Annual Monitoring Report

Monitoring Year 7 of 7

601 East Stream Restoration Project
NCDMS Contract No.: 004925
NCDMS Project No.: 95756
USACE Permit Action ID: 2013-00265
DWR Project No.: 14-0547

RE: 601 East Stream Restoration Site: MY7 Monitoring Report (NCDMS ID 95756)

**Current Conditions
Plan View**

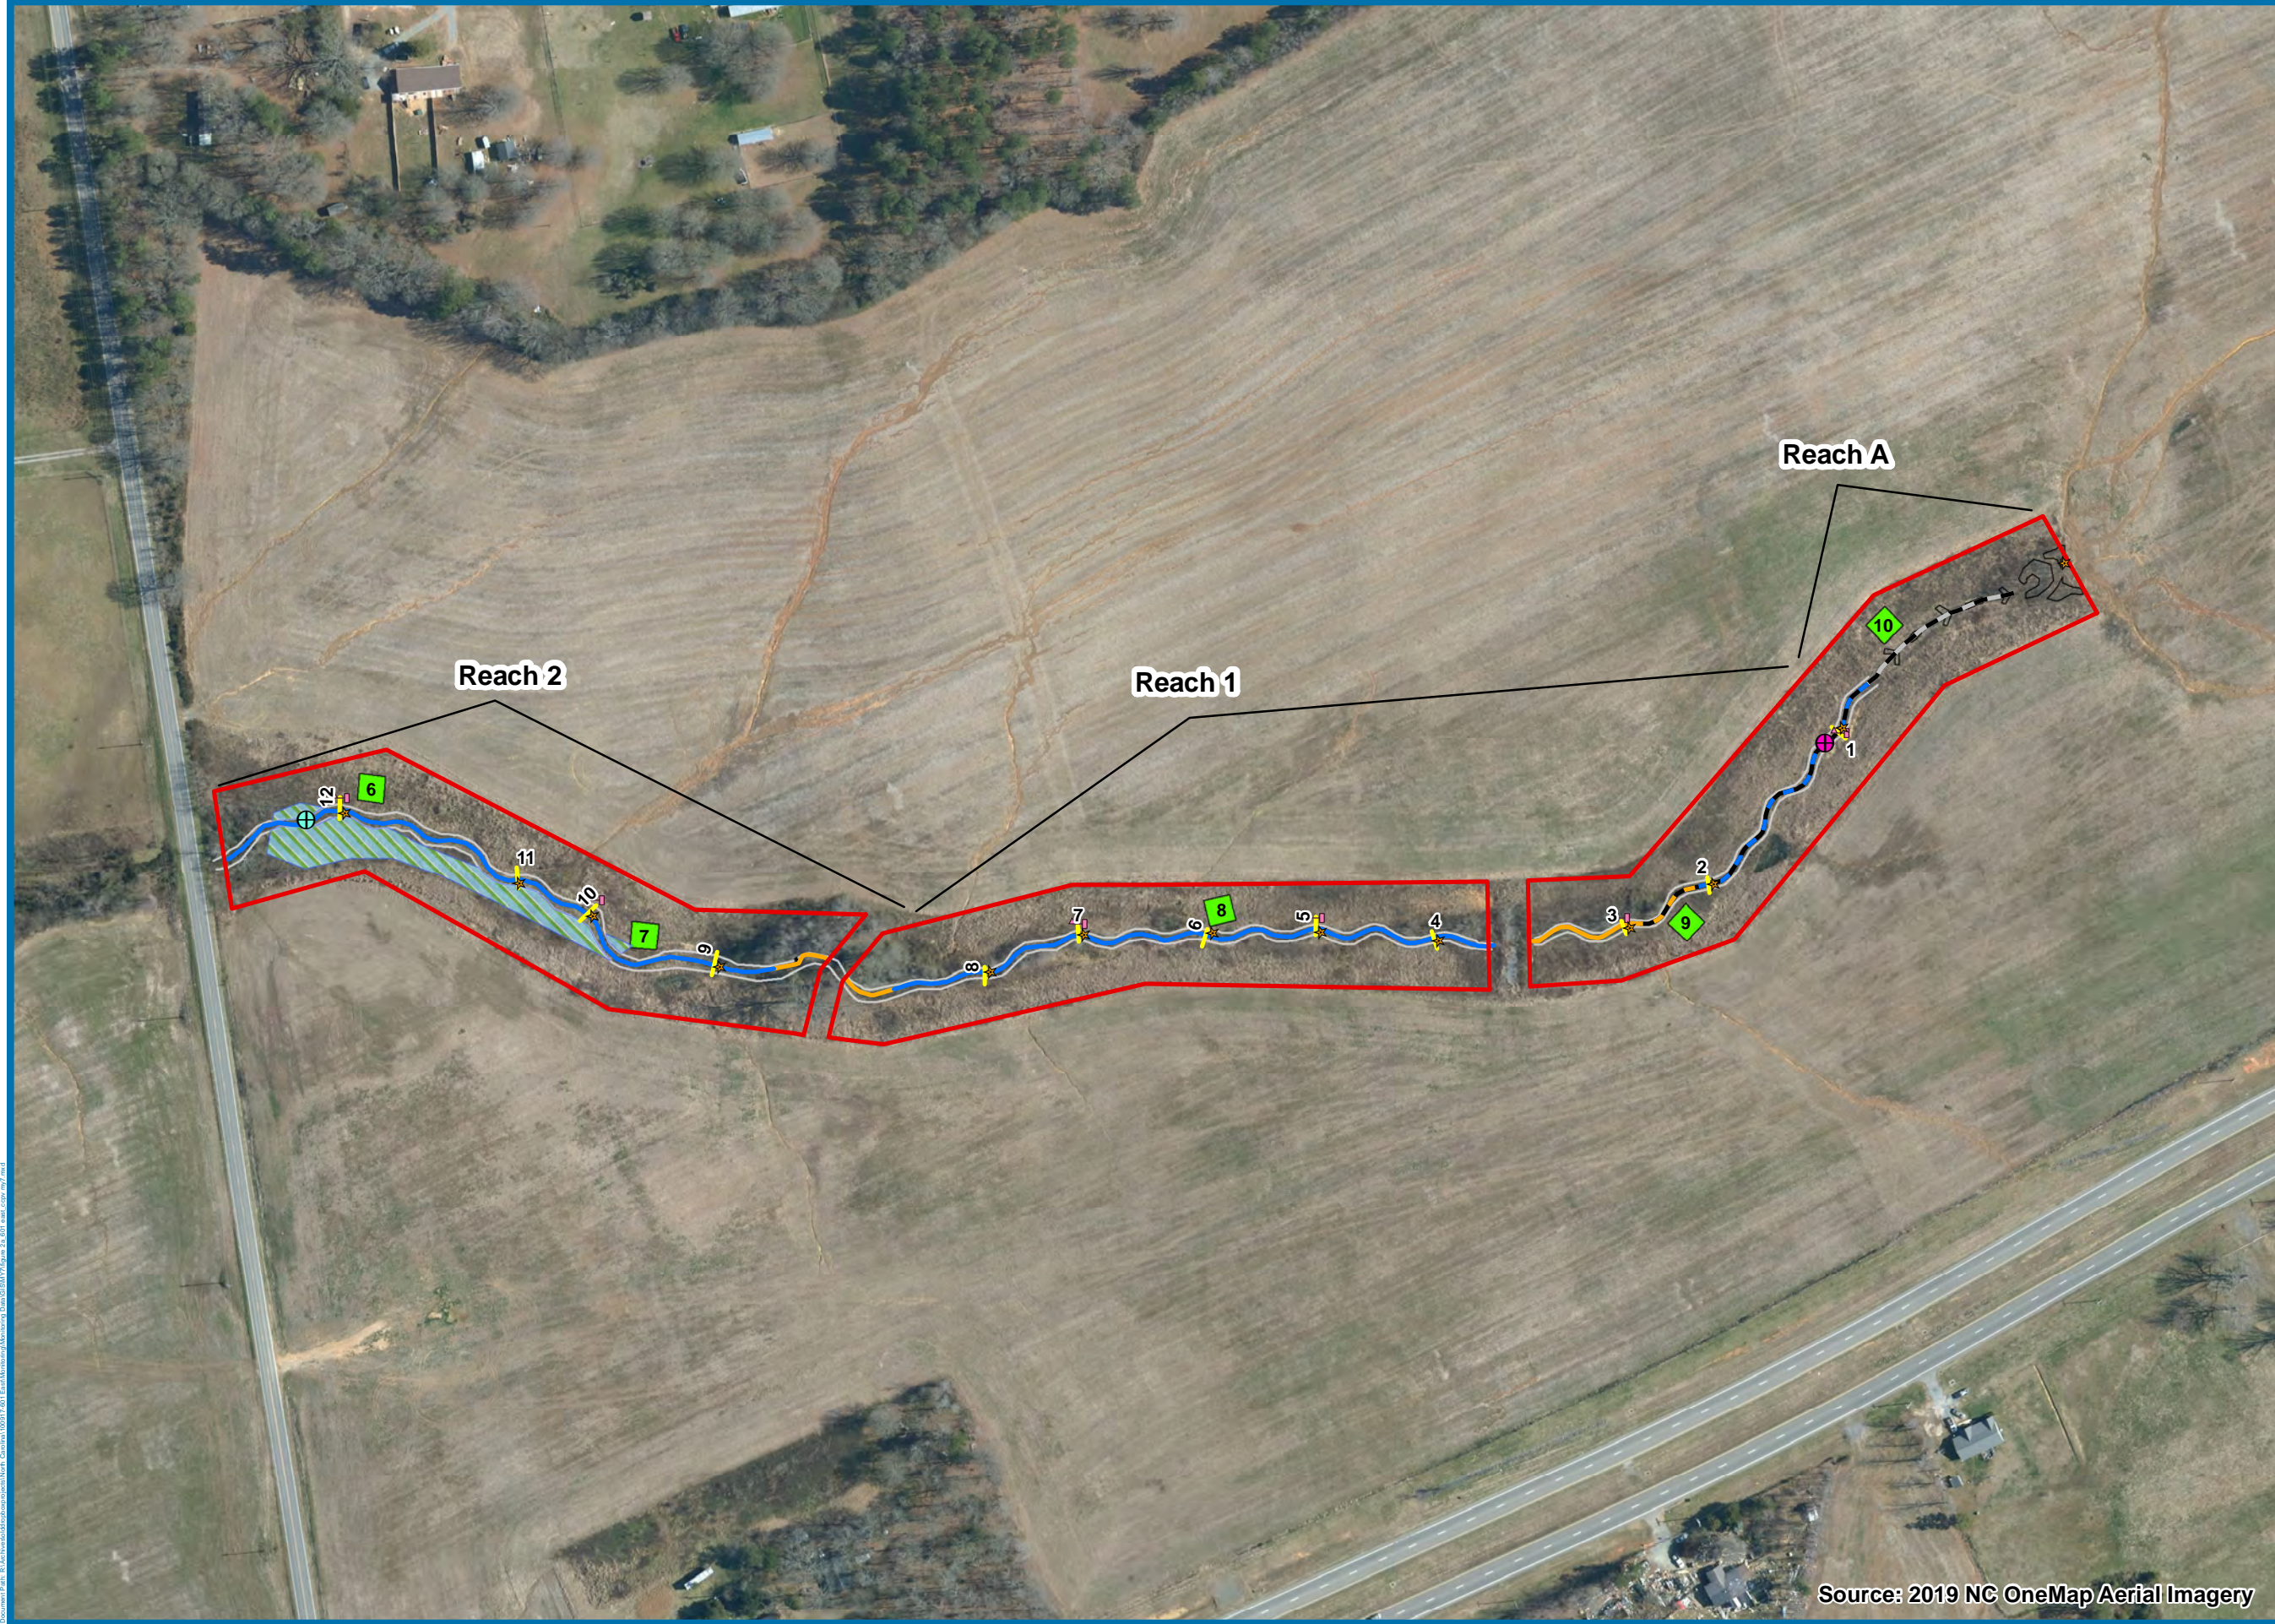
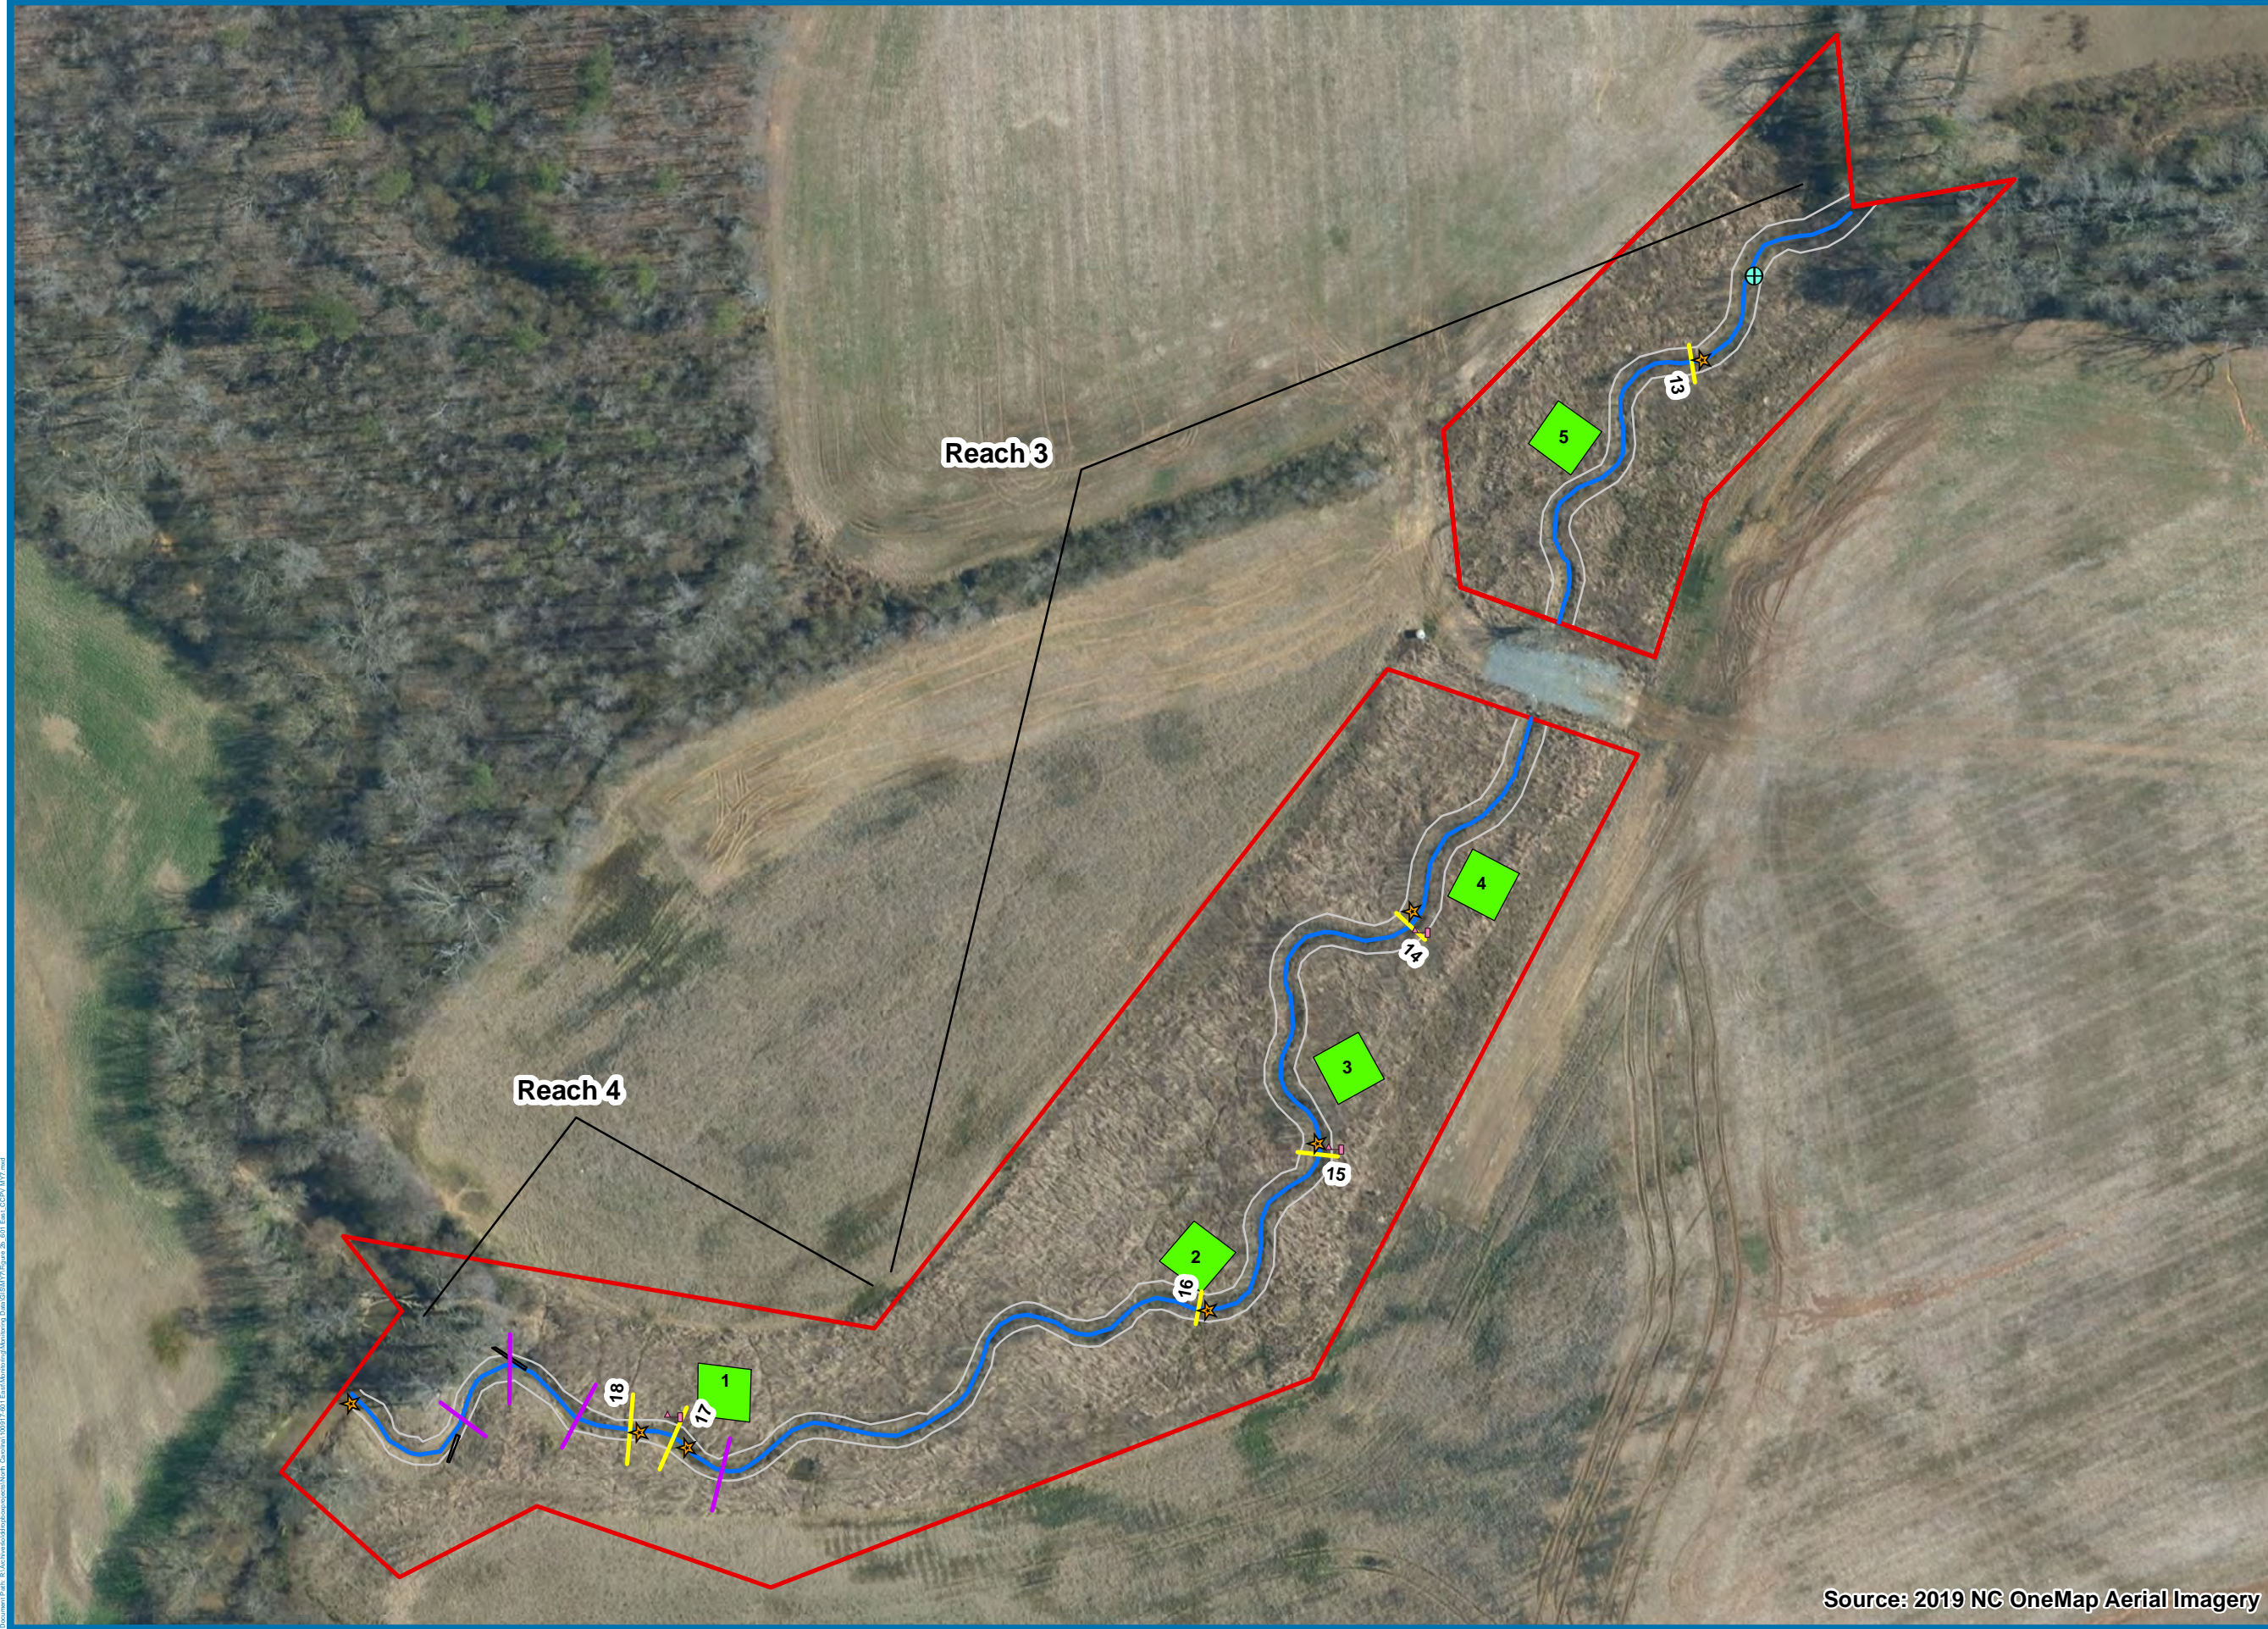
CCPV Maps: If possible, please update the aerial imagery to the most recent available. As noted on the maps, current aerial imagery is from 2019.

The most recent NC OneMap aerial for this region is from 2019. Additionally, the most recent Google Maps Satellite imagery is also from 2019.

MY7 2021 601 East Reach 1 Flow Gauge

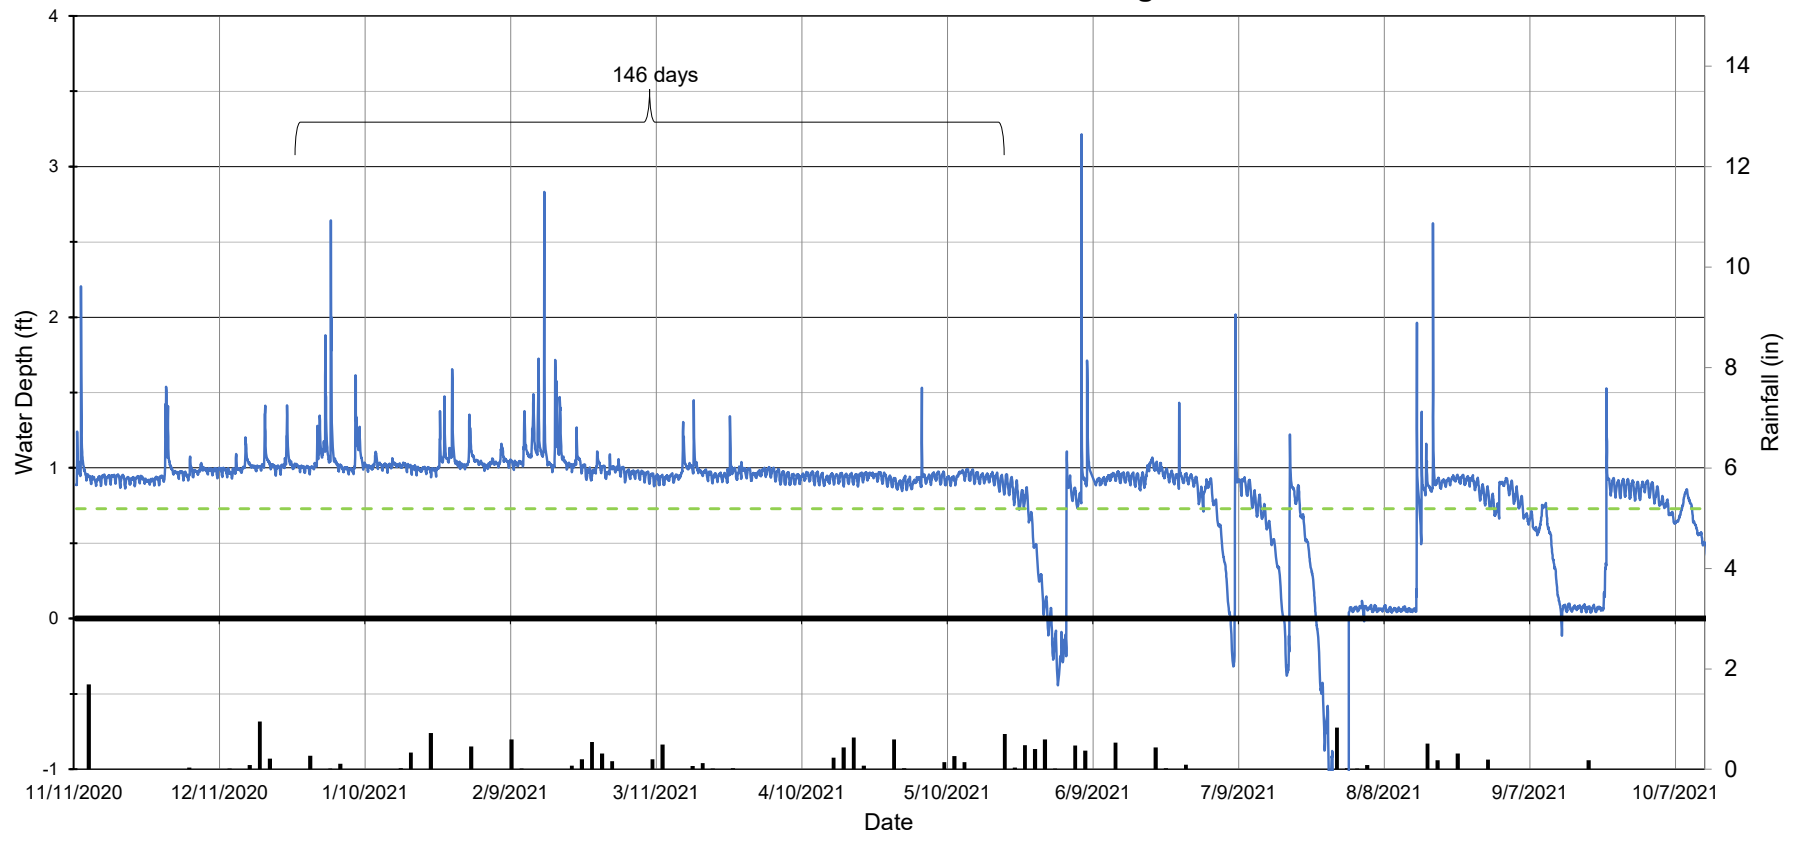
Appendix E – Flow Gauge Graph: DMS recommends showing the start and end points of the 146 days of consecutive flow reported.

Done.
